Intersection ID: N/A	Main Street: WINSLET_DR	Cross Street: N/A	Location:	SE
ADA ID: 0C399BB51569	Ramp Type: Perp	Initial Pass/Fail: Fail	Overall Compliance: No	Severity Score: 26.25

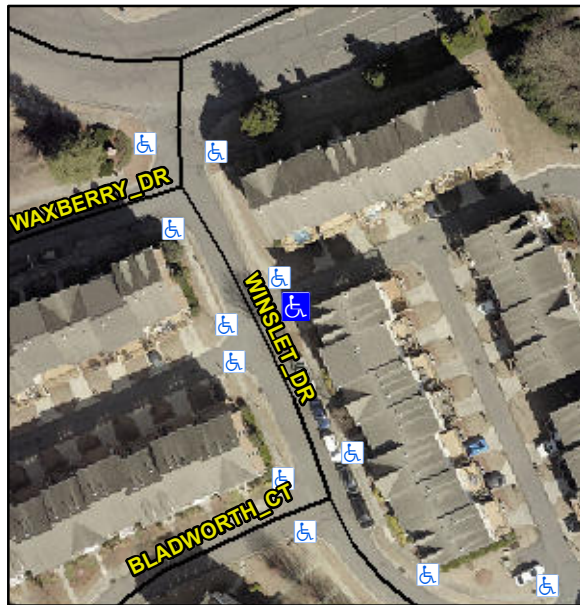
**Not Found, R304.2.2, R304.5.3**

Possible Solutions:			Compliance	Description	Data	Compliance	Description	Data		
<b>Remove &amp; Replace Entire Ramp.</b>			N/A	Ramp Length (in)	45.0	No	Ramp Slope (%)	13.3		
			Yes	Ramp Width (in)	48.0	No	Ramp XSlope (%)	4.3		
			N/A	Flare Type LT	N/A	N/A	Flare Type RT	N/A		
			N/A	Flare Slope LT (%)	N/A	N/A	Flare Slope RT (%)	N/A		
			N/A	Flare Traversable LT?	N/A	N/A	Flare Traversable RT?	N/A		
			N/A	Landing Length (in)	N/A	N/A	DWS Provided?	N/A		
			N/A	Landing Width (in)	N/A	N/A	DWS Contrast?	N/A		
			N/A	Landing Slope (%)	N/A	N/A	DWS Length (in)	N/A		
			N/A	Landing X Slope (%)	N/A	N/A	DWS Full Width?	N/A		
			N/A	Landing Curb? (Y/N)	N/A	N/A	DWS Offset (in)	N/A		
Surveyor Notes: <b>N/A</b>			N/A	Shared Landing?	N/A					
			N/A	Gutter Ponding?	N/A	N/A	Gutter Slope (%)	N/A		
			N/A	Gutter Lip Ht (in)	N/A	N/A	Gutter X Slope (%)	N/A		
			N/A	Painted X Walk1?	No	N/A	Painted X Walk2?	N/A		
				X Walk 1 Direction	To N		X Walk 2 Direction	N/A

N/A	X Walk 1 Width (in)	N/A	N/A	X Walk 2 Width (in)	N/A		
				X Walk 1 Slope (%)	1.2		X Walk 2 Slope (%)	N/A		
				X Walk 1 X Slope (%)	0.2		X Walk 2 X Slope (%)	N/A		
			N/A	Ramp inside XWalk1?	N/A	N/A	Ramp inside XWalk2?	N/A		
				Road Slope (%)	N/A	N/A	Clear Space?	N/A		
PROW/ADA: <b>Not Found, R304.2.2, R304.5.3</b>				Road X Slope (%)	N/A	N/A	Clear Space to XWalk (in)	N/A		
			N/A	Any Obstructions?	N/A	N/A	Storm Grate/Utility Hazard?	N/A		
				Obstruction Type			Storm Grate/Utility Type			
					N/A			N/A		
						Yes	Surface Condition? (G/P)	Good		
			Total Cost:			\$	1850.00

### Remove & Replace Entire Ramp.
